November 24, 2021

Subject: North Shoreview Elementary School HVAC Replacement
San Mateo - Foster City School District
Aedis Project No. 2021005.05
DSA Application #01-119554

ADDENDUM NO. 1

DEMO SINGLE
LINE DIAGRAM

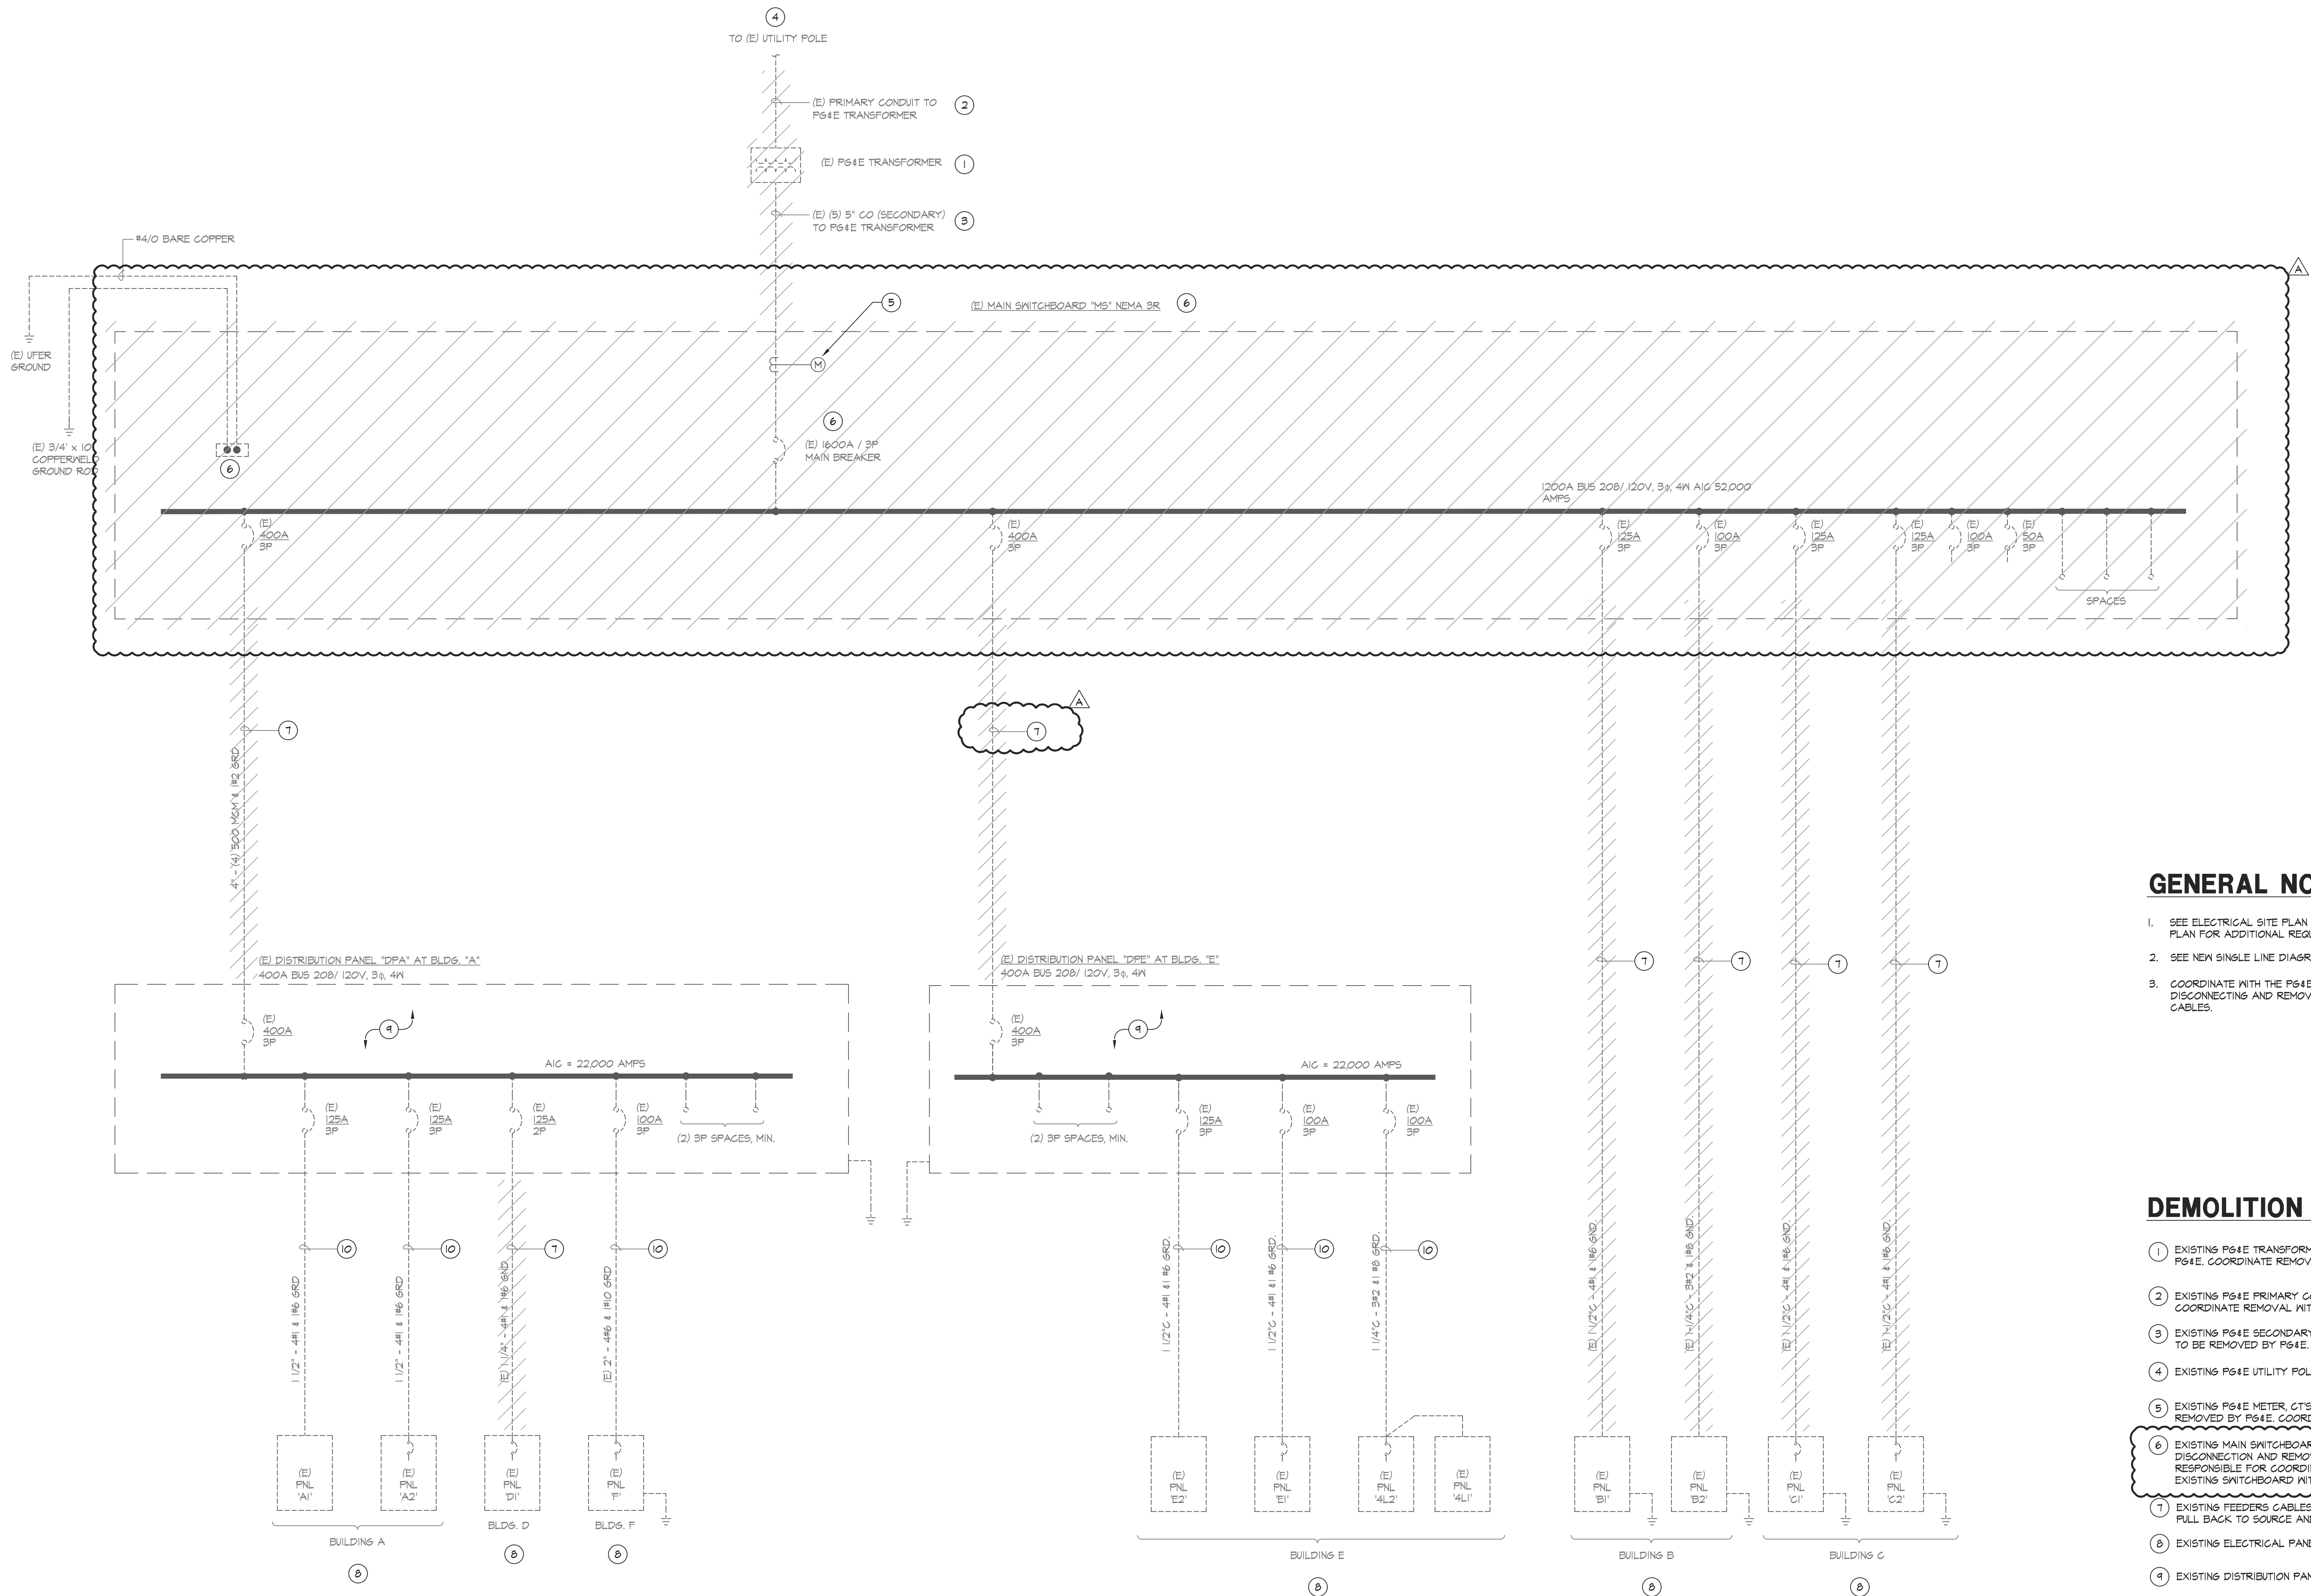
Revise: Demolition Sheet Note #6 per AD1-E4.1.
Revise: Demolition requirements for Main Switchboard per AD1-E4.1
